This Service Letter reidentified as  
 Service Bulletin M 20-90  
 per Service Instruction M20-15.

**SUBJECT:** Battery Access Door Installation

**MODELS AFFECTED:** M20, M20A & M20B, Serial Numbers 1002 thru 1939

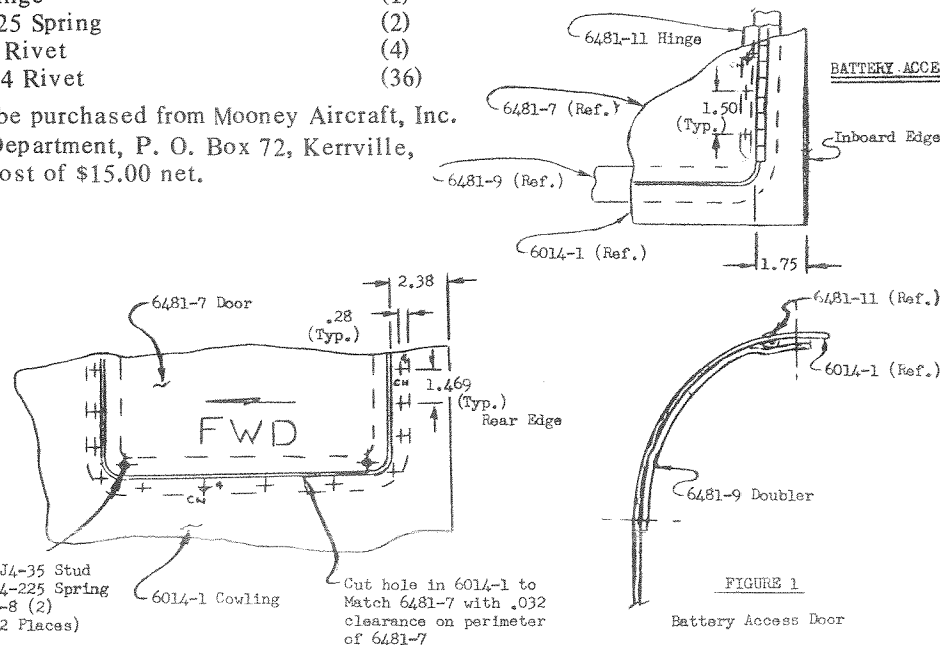
1. Remove 6014-1 L.H. cowling from the aircraft.
2. Lay the 6481-7 door on the cowling to the dimensions shown in Figure 1.
3. Scribe around 6481-7 door leaving .032 clearance around the outside of 6481-7 door.
4. Cut hole in 6014-1 along scribed line.
5. Drill door and hinge to match rivets as shown in Figure 1.
6. Drill 6014-1 cowling to match 6481-9 doubler and 6481-11 hinge as shown in Figure 1. Cleco doubler and hinge to 6014-1 cowling.
7. Drill 6014-1 cowling and 6481-9 doubler to dimensions shown in Figure 1 and rivet.
8. Drill .250 dia. hole in 6481-9 doubler to match Dzus FJ4-35 stud in 6481-7 door.
9. Countersink hole in 6481-9 doubler to match countersink in 6481-7 door.
10. Install Dzus S4-225 spring with two AN426A-8 rivets on back of doubler, two places.
11. Install cowling on aircraft.

Cut hole in 6014-1 to  
 Match 6481-7 with .032  
 clearance on perimeter  
 of 6481-7
